From: Mark Reynolds <mreynolds@etv.net>
To: <kboyer@fs.fed.us>
Date: 10/5/2006 5:19:39 PM
Subject: Bear Canyon Lease Addition

Attached is a draft response to the Forest Service comments on the DOGM permit amendment. If you have any question please call me.

Figure 3-1 Utah Sensitive Endangered Mammalian Species in Relation to Permit Area
(created by the Utah Division of Wildlife Resources May 3, 2006)

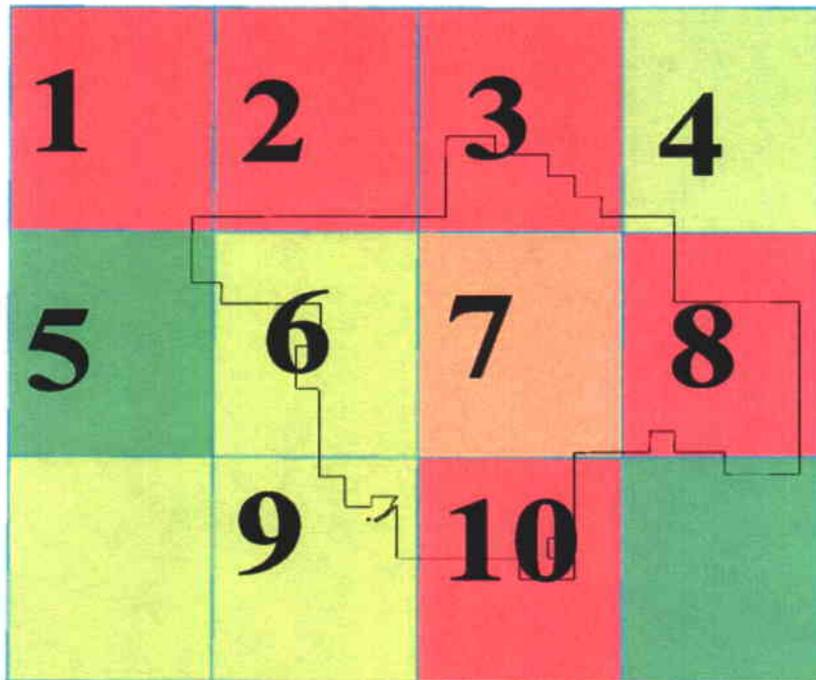
28. Page 3-29, Figure 3-1
Changes the heading to Utah Sensitive Species in Relation to the Permit Area.

The heading was changed.

17. Hydrology, Table 714, Water Monitoring Matrix, pg. 7-53.

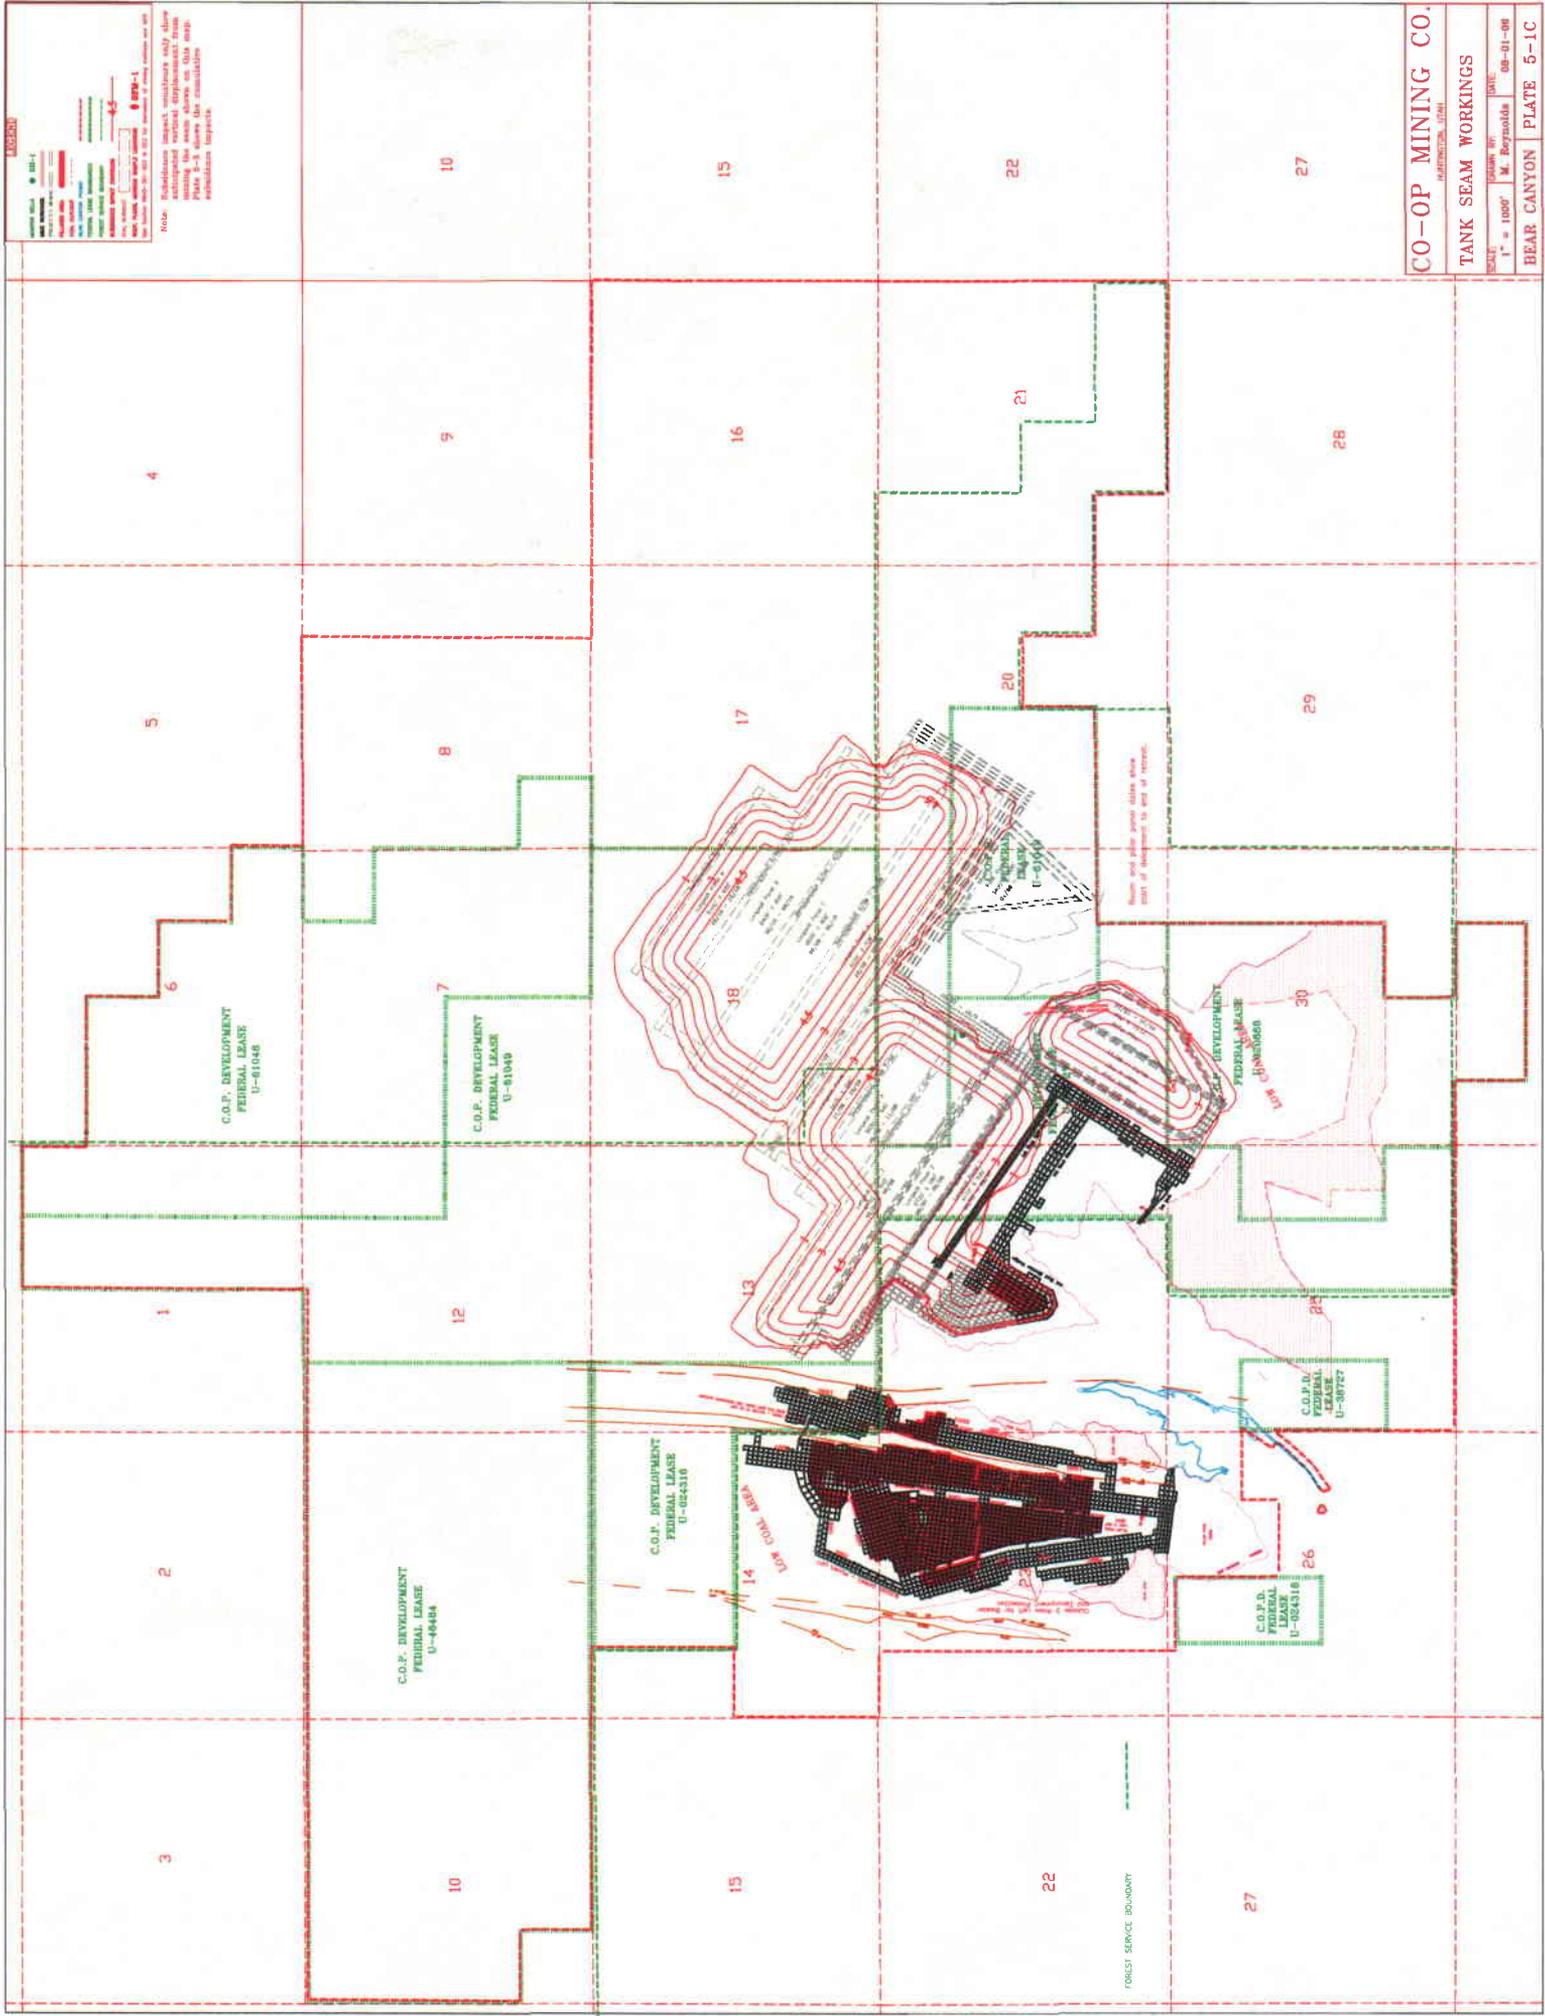
The table needs to be updated to reflect recent discussion and field trip findings regarding additional sampling locations:

- a) 2 additional surface water monitoring points in the McCadden Hollow drainage.
- b) 1 new spring or seep location to be determined in T.16S., R.7E, Section 10.
- c) 2 springs in T. 16S., R.8E., Section 19 (SBC 16-A and SBC-16B).
- d) The "Area Of Concern" in T. 16S. R.8E., Section 19.

Table 7-14 (pg 7-53) and Plate 7-4 have been updated to reflect all recent discussions.

- a) Only one site was added because the last spring visited in McCadden Hollow was north of the permit area
- b) There was no spring found in this section, however, we did visit springs in Section 12 and 13, these were added as SMH-5 and SBC-22 respectively.
- c) These were added
- d) This area is primarily in Section 18 and extends down into 19. The source is being monitored as SBC-21. SBC-20 was also added to help monitor this area.

SUBSIDENCE MAP

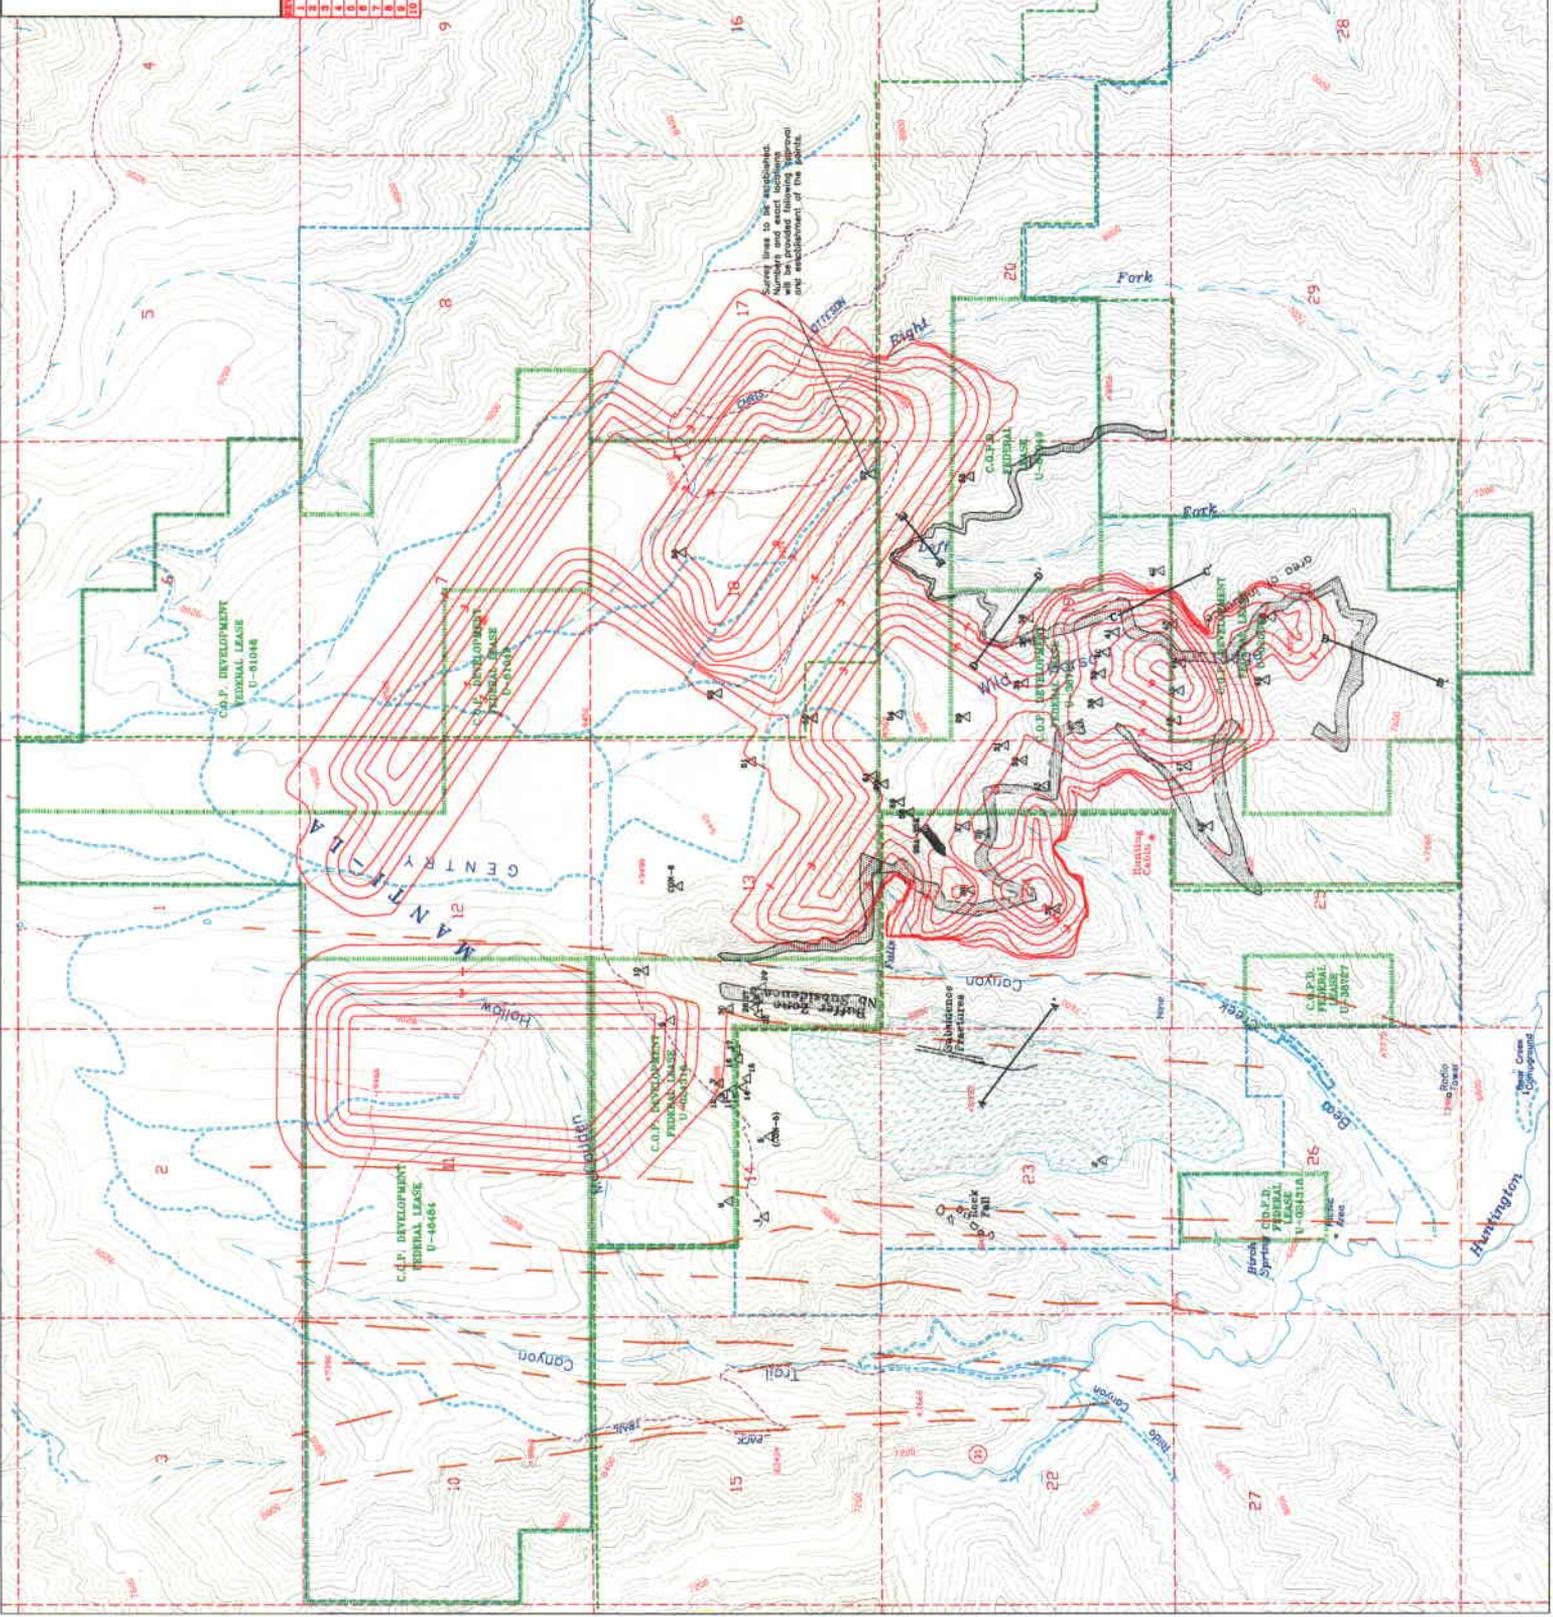
19. Subsidence Map, Plate 5-3A.

The castlegate sandstone needs to be mapped throughout the permit revision area.

The castlegate sandstone is shown on Plate 5-3, and 5-3A in all areas of concern.

WATER RIGHTS

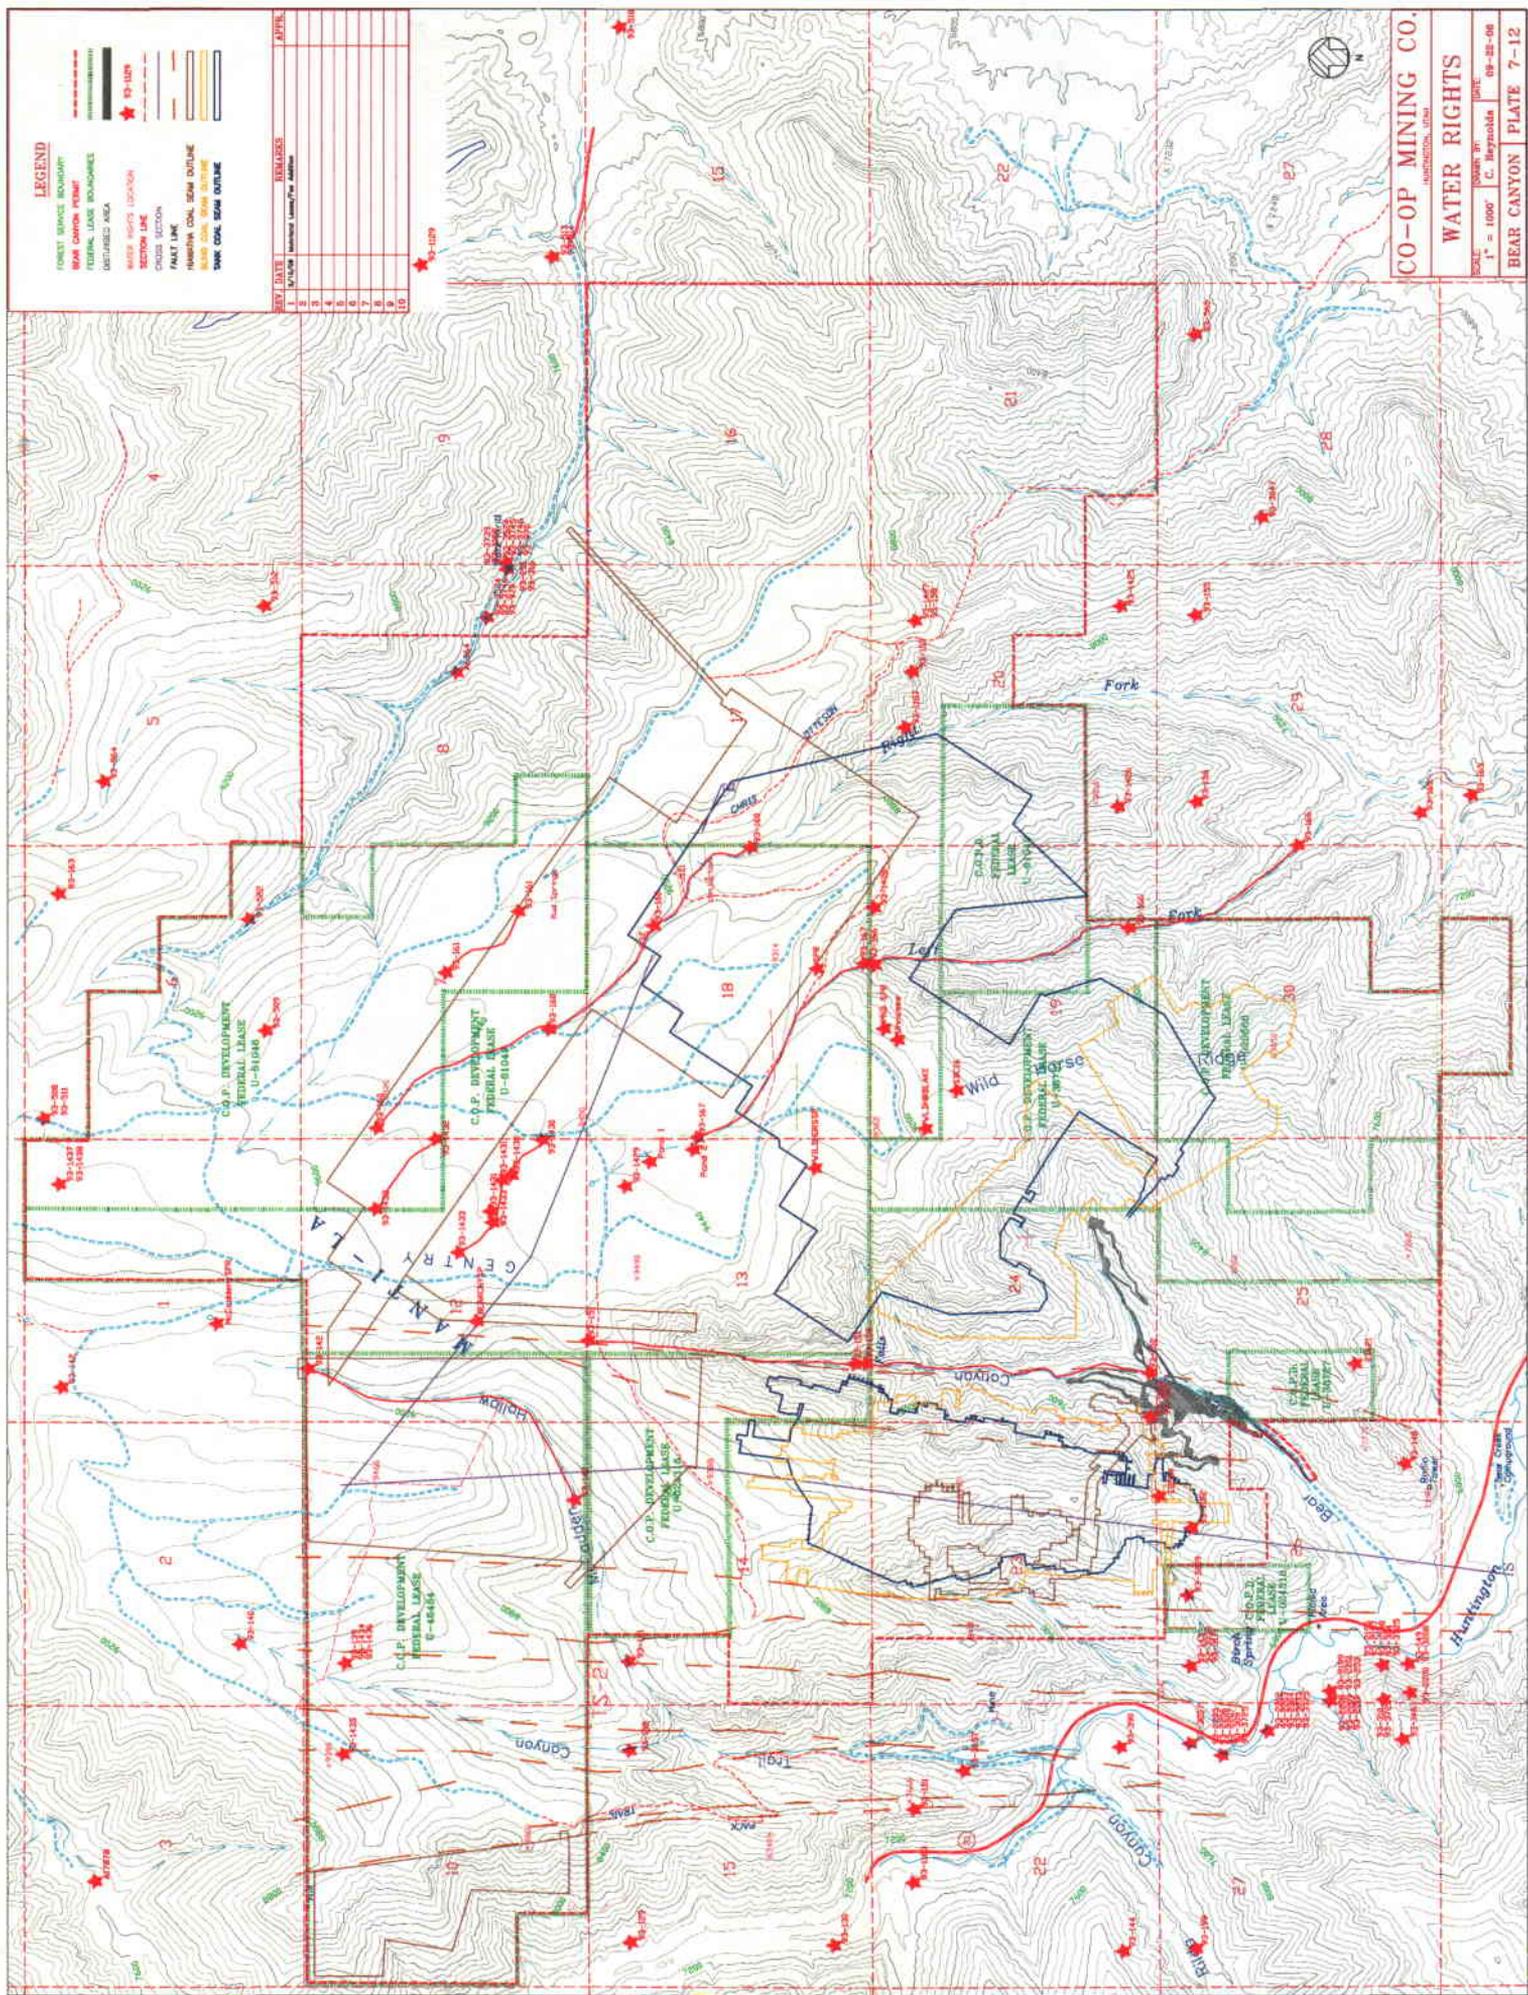
22. Plate 7-4 and Plate 7-12.

Both of these plates are titled Water Monitoring and dated the same. Both are not needed. Put all correct information on one and delete the other. Update the plate to reflect the recently approved monitoring locations.

Plate 7-4 is Water Monitoring and Plate 7-12 is Water Rights. The titles have been corrected and both plates have been updated.
